Red Line Revisions to NCDH Approved Drawings

MODIFICATIONS TO
AQUA NEW YORK, INC.
WATER TREATMENT FACILITY
SEAMANS NECK ROAD
NASSAU COUNTY, NEW YORK

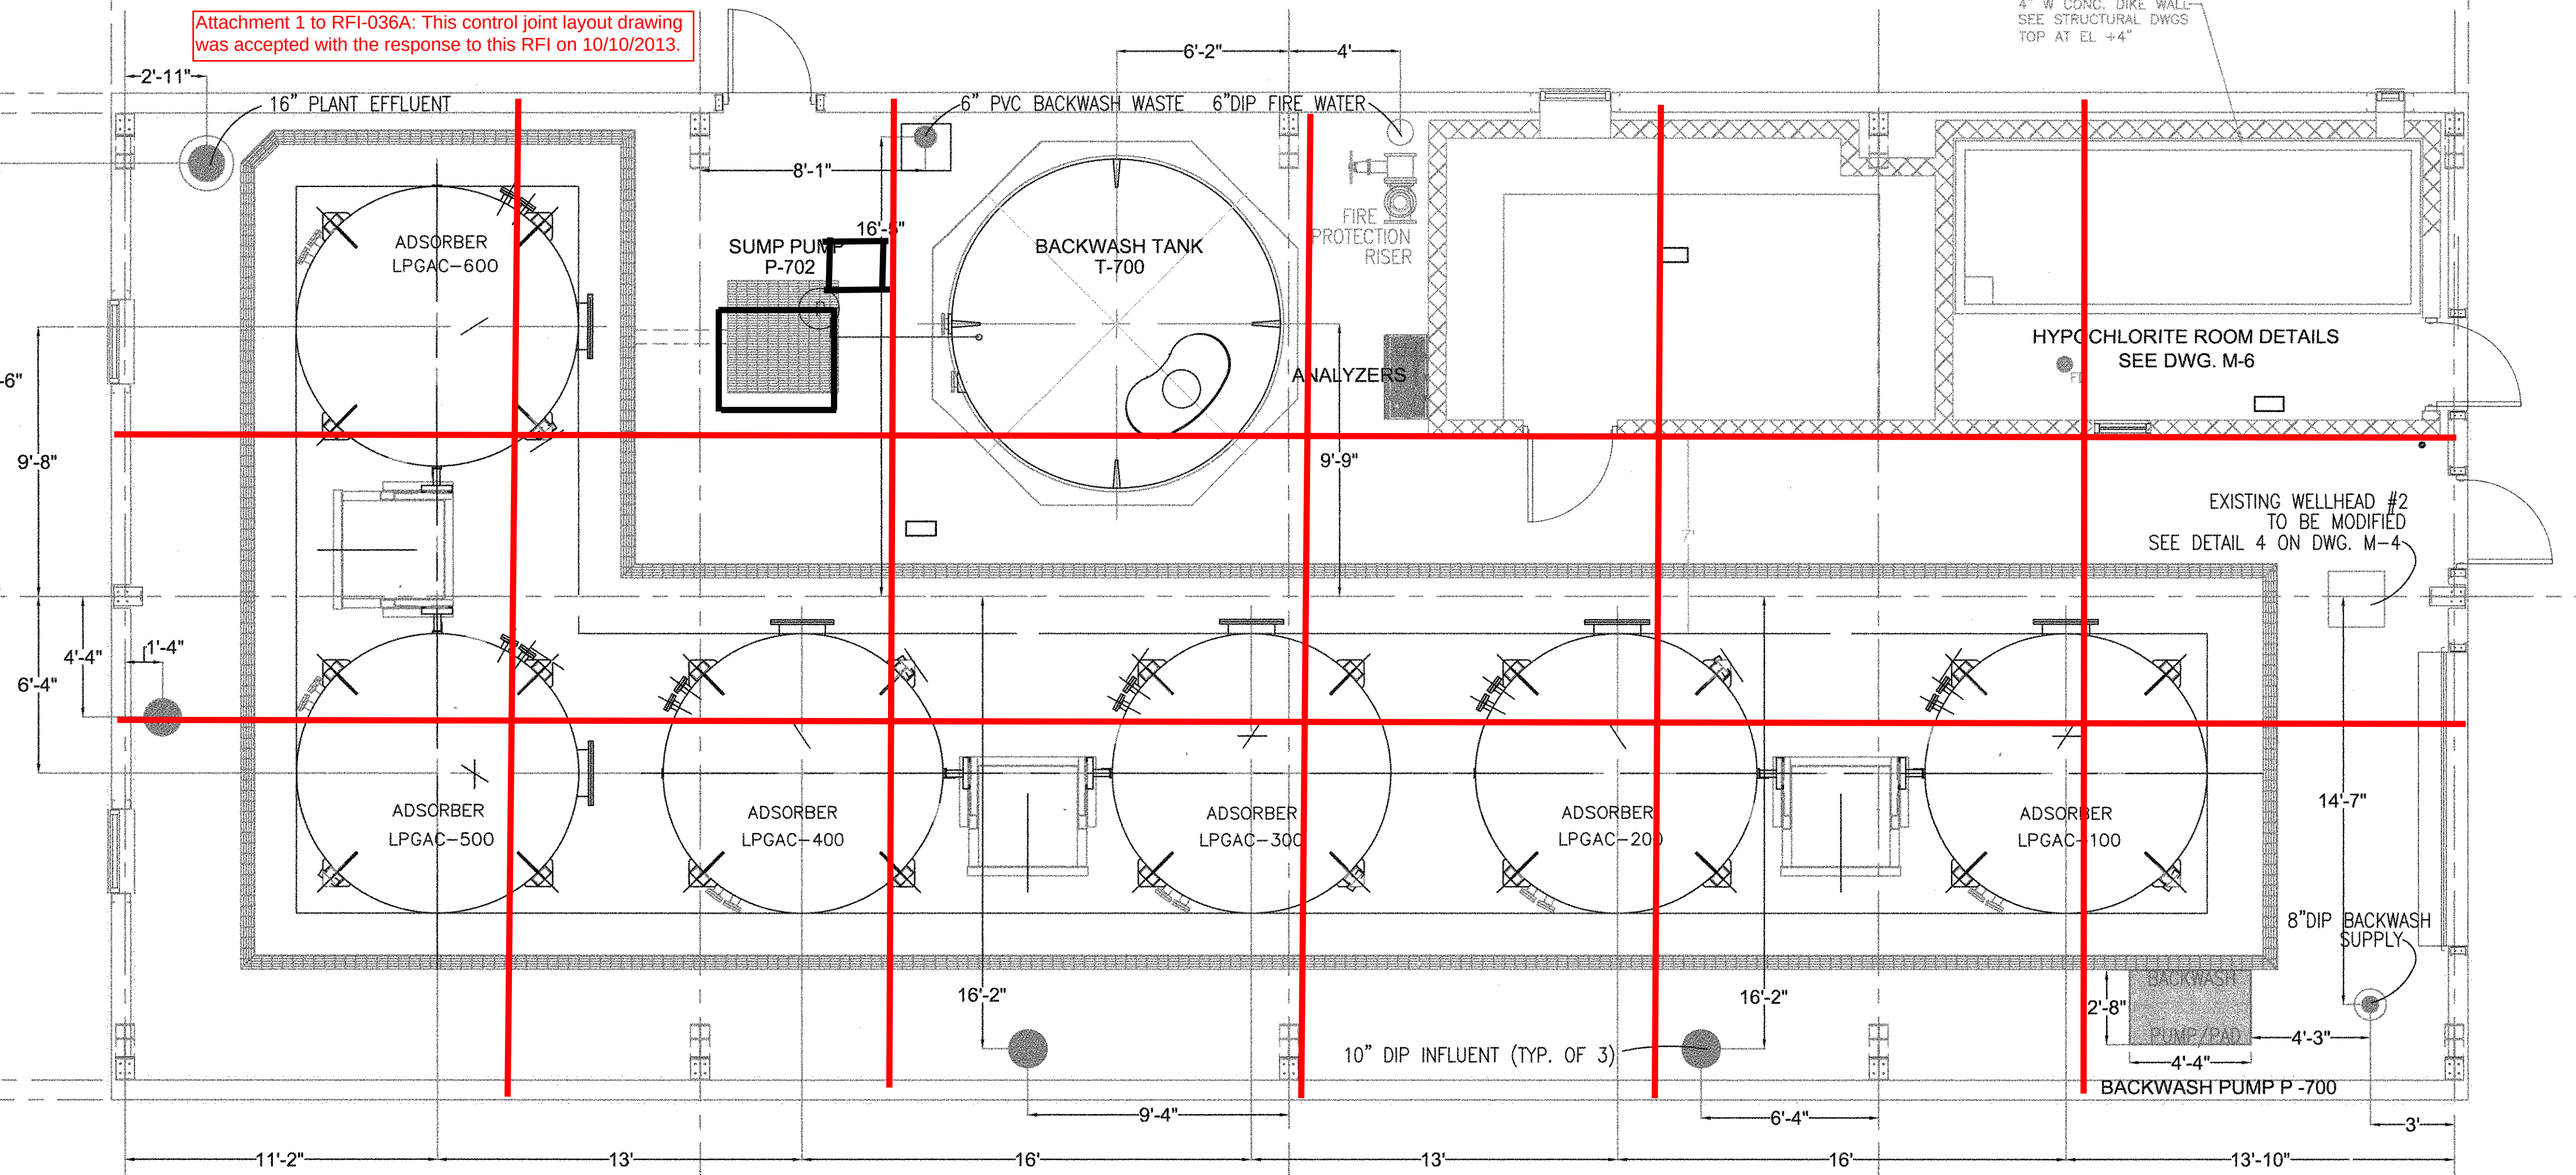
Attachment 1 to RFI-036A: This control joint layout drawing was accepted with the response to this RFI on 10/10/2013.

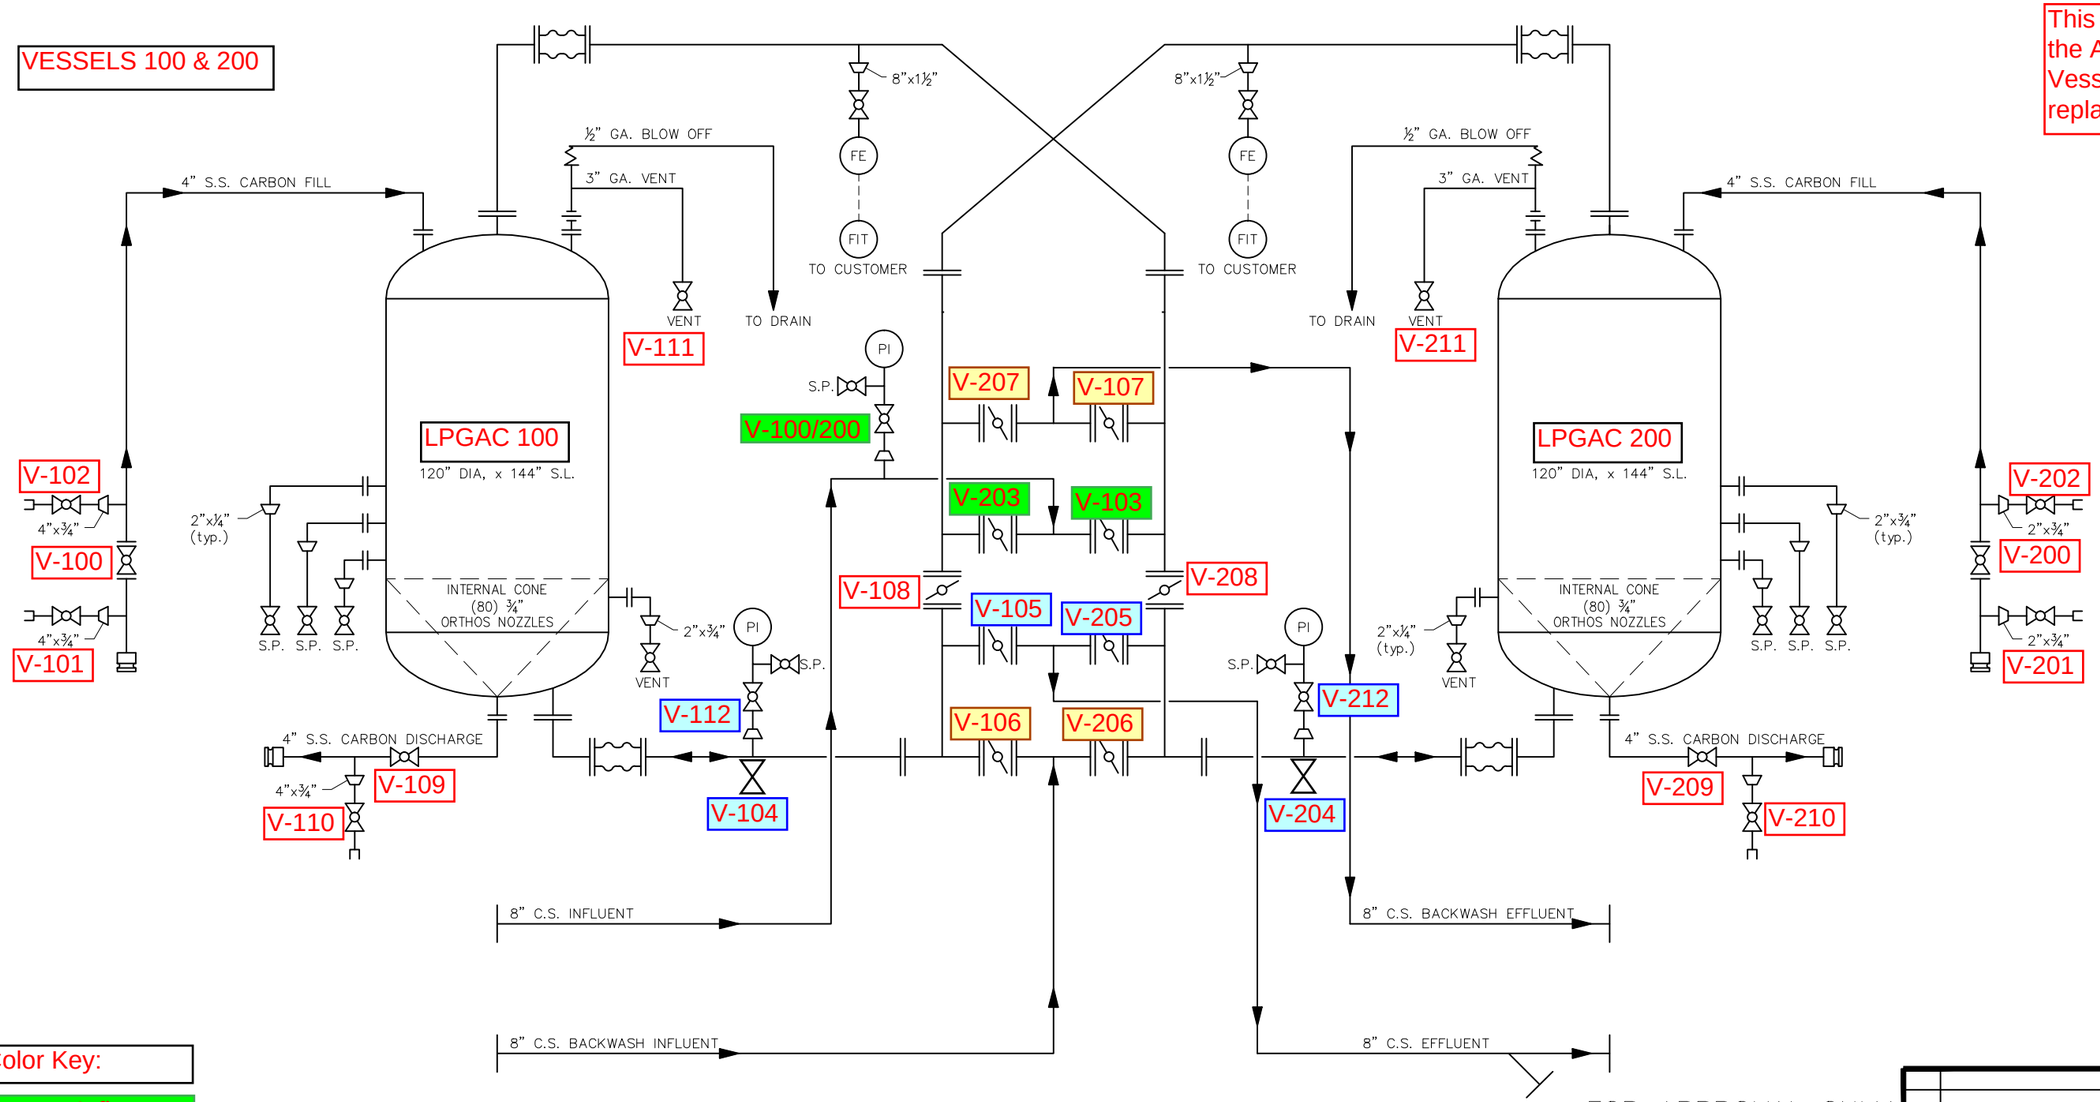
This Drawing Represents the As-Built for GAC Vessels 100 & 200, and replaces drawing PID-3

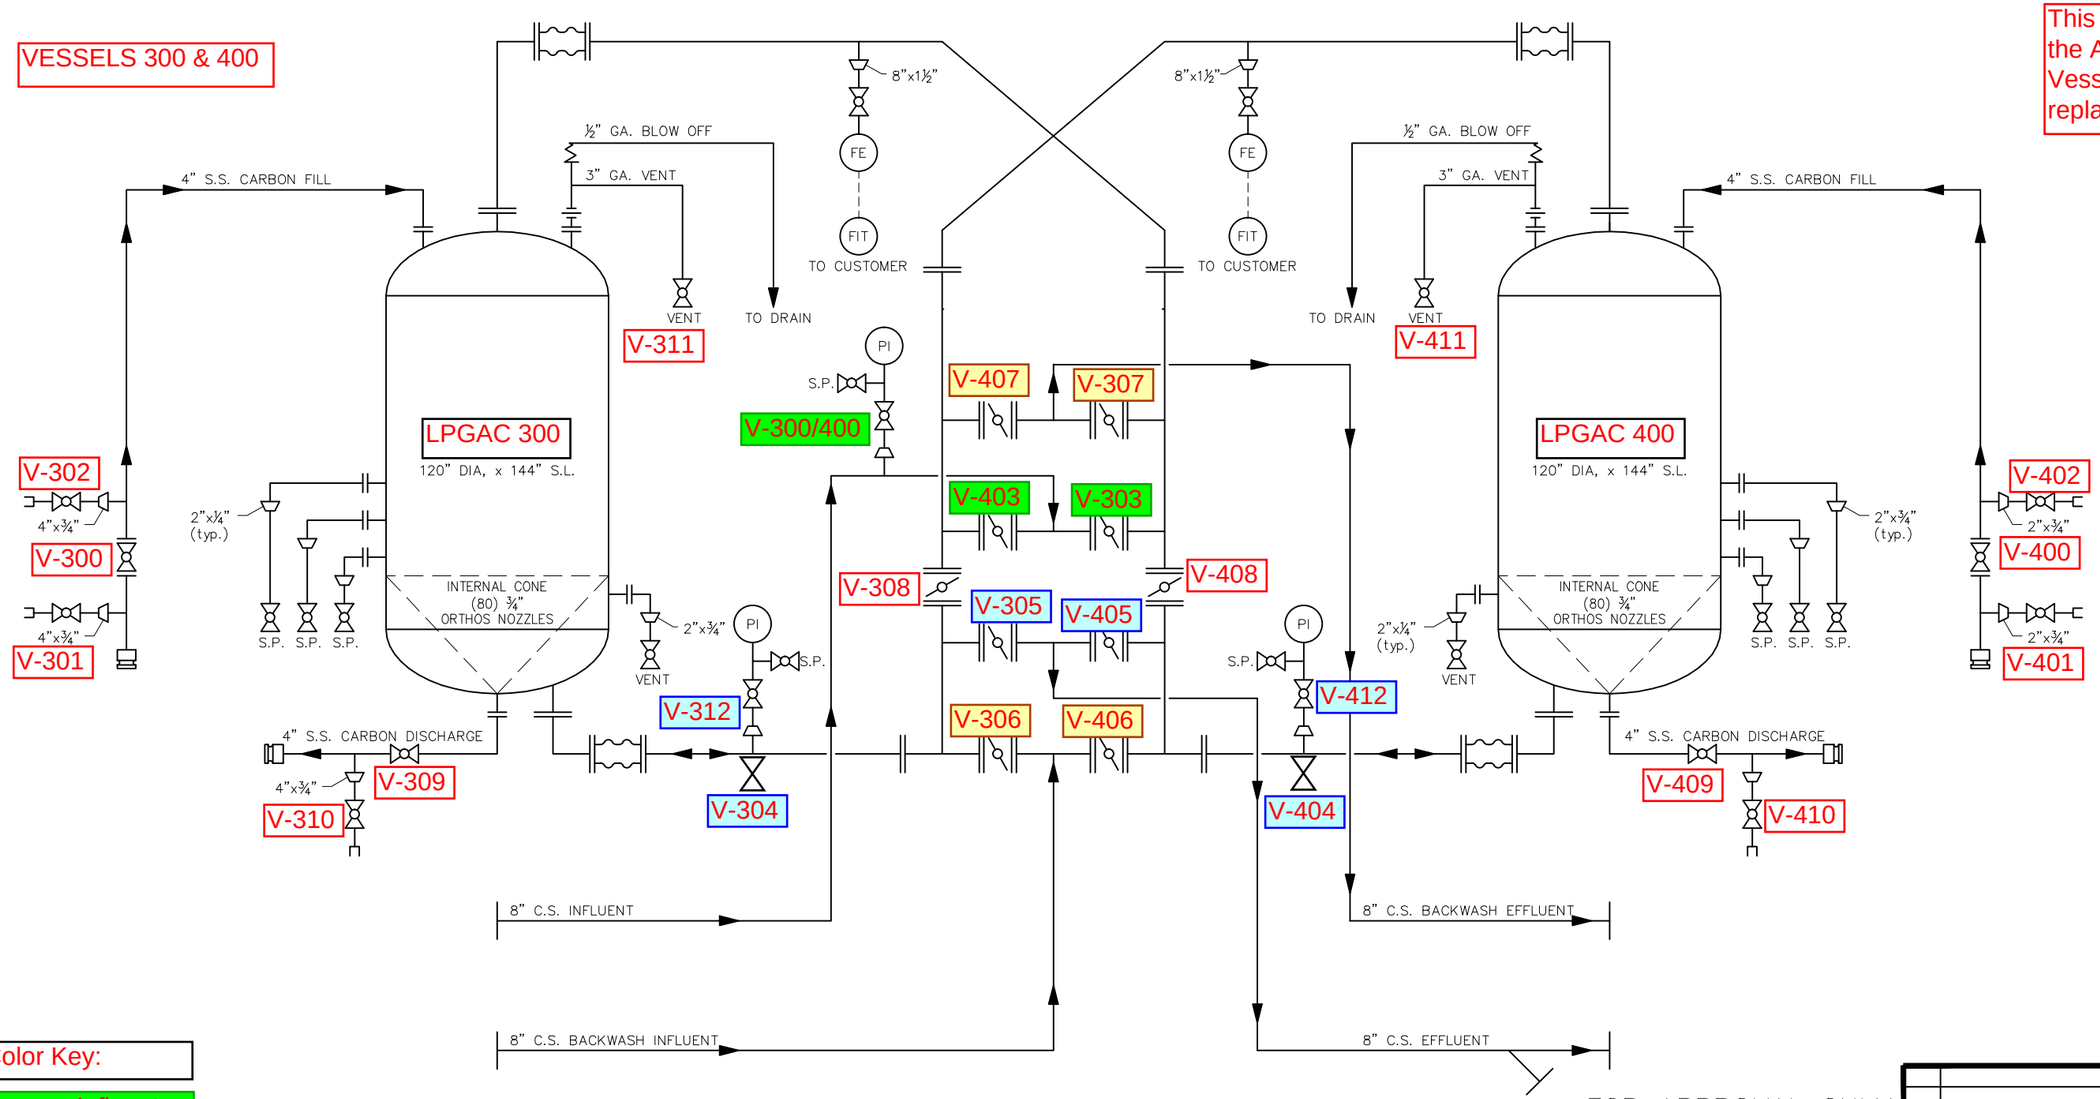
This Drawing Represents the As-Built for GAC Vessels 300 & 400, and replaces drawing PID-4

VESSELS 500 & 600

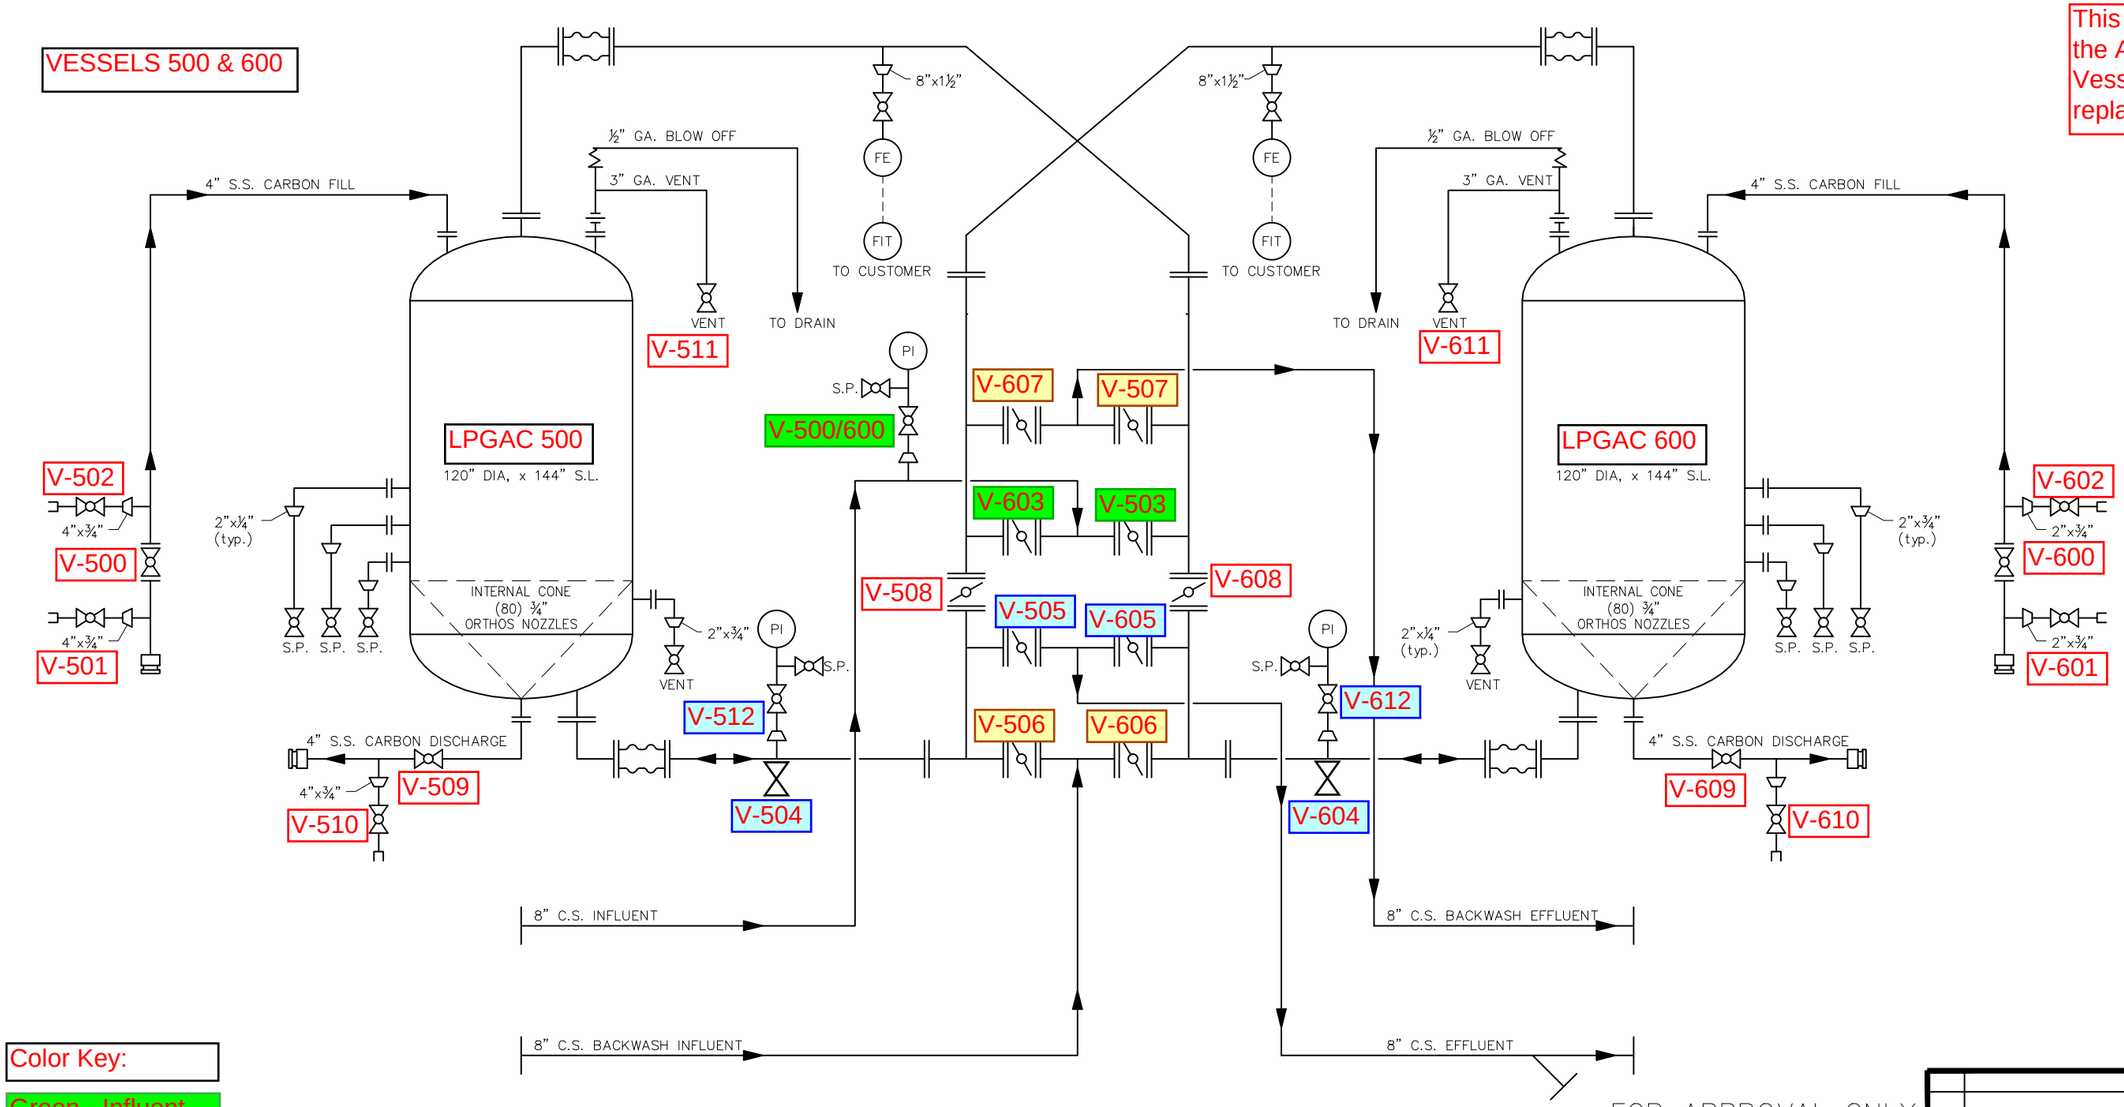
This Drawing Represents the As-Built for GAC Vessels 500 & 600, and replaces drawing PID-5

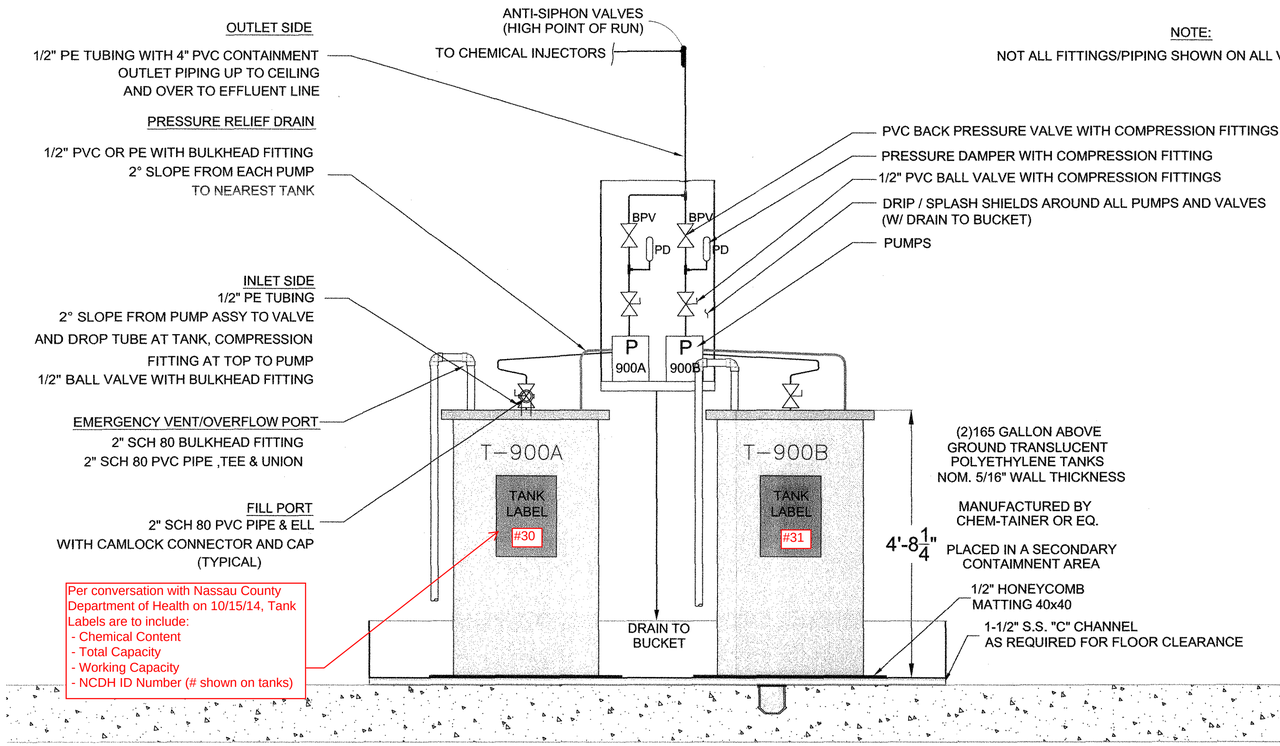
Per conversation with Nassau County Department of Health on 10/15/14, Tank Labels are to include:
- Chemical Content
- Total Capacity
- Working Capacity
- NCDH ID Number (# shown on tanks)
